37/03-05U 7211 Maple Ave  
Takoma Park Historic District

SUBJECT: Historic Area Work Permit for window sash replacement and addition

**HISTORIC PRESERVATION COMMISSION STAFF REPORT**

**PROPOSAL:** Window Replacement and Addition

**REPLACEMENT WINDOW TYPES**

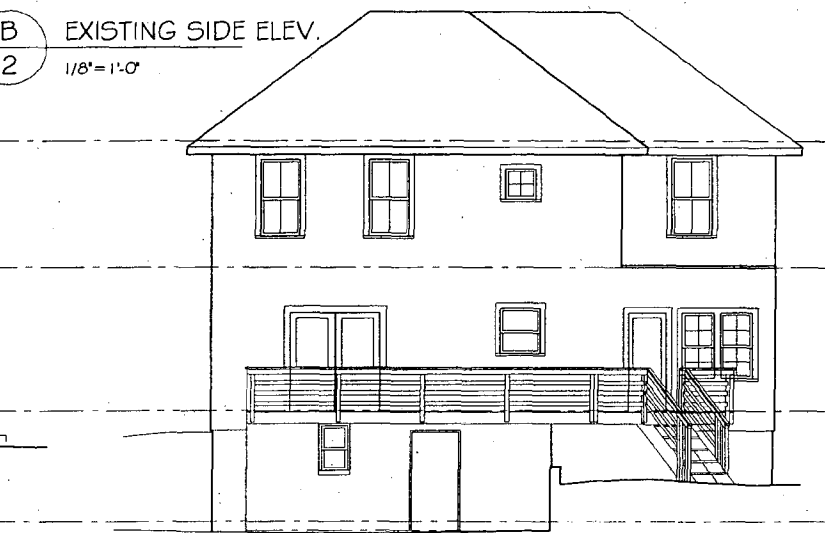
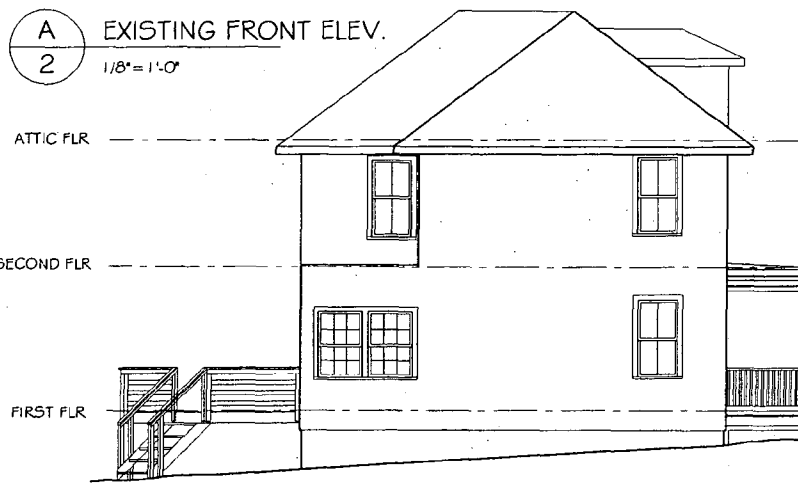
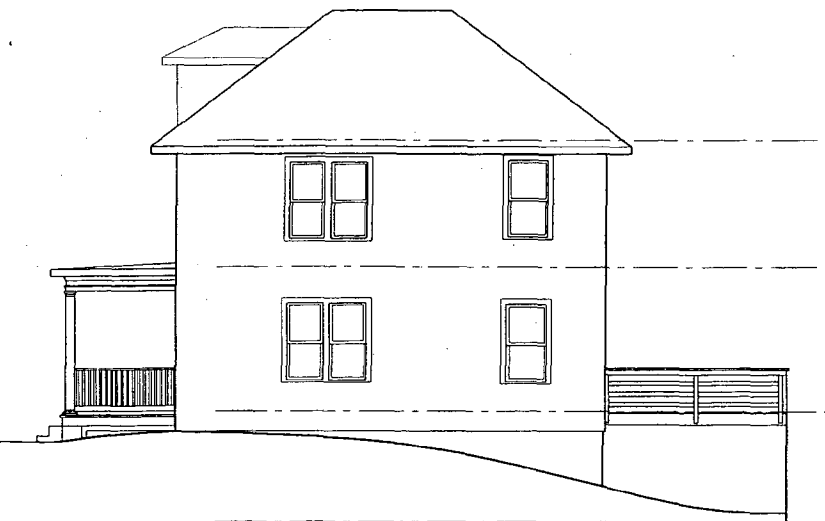
The applicants are proposing to replace all of the window sashes on the house with new, wood insulated Marvin window sashes and new jamb liners. The applicants are proposing replacement of the 1/1 and 2/2 single-pane, double-hung, wood windows with wood, double-pane 1/1 and 2/2, true-divided light, wood windows. The proposed, new 2/2 windows will closely match the original muntins (see photo of existing window on circle ). The existing muntins are 1-3/4" wide (or 1-12/16" wide) at the glass face and the applicants are proposing to replace them with the Marvin window, which has a 1-11/16" wide muntin.

- 1. The applicant will remove the asbestos siding from the house and provide a condition's assessment of the exposed, wood siding for the staff's review. It will be required, however, if it is determined that a holistic replacement is needed, that the siding be replaced with wood siding to match the existing in profile and design.**
- 2. The size of the window openings will not be altered during the sash replacement.**

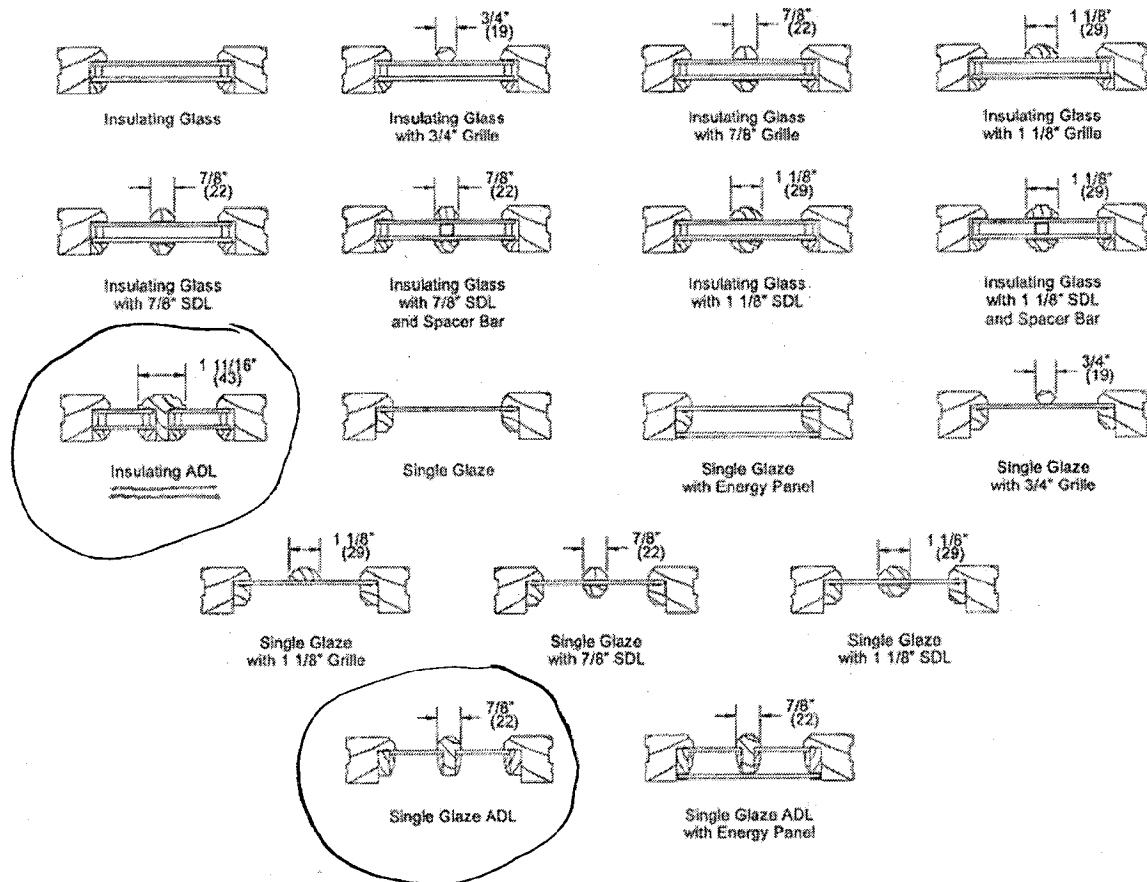
In response to your suggestions at the April 6<sup>th</sup> meeting (with clients David Reiser, Irene Huntoon and architect Jane Treacy) we've looked into manufacturers of true-divided lite replacement windows. Marvin provides an insulated true-divided lite ("actual divided lite"-ADL) option and I wanted to run the choice by you to see if the committee would have any objections.

*OK*
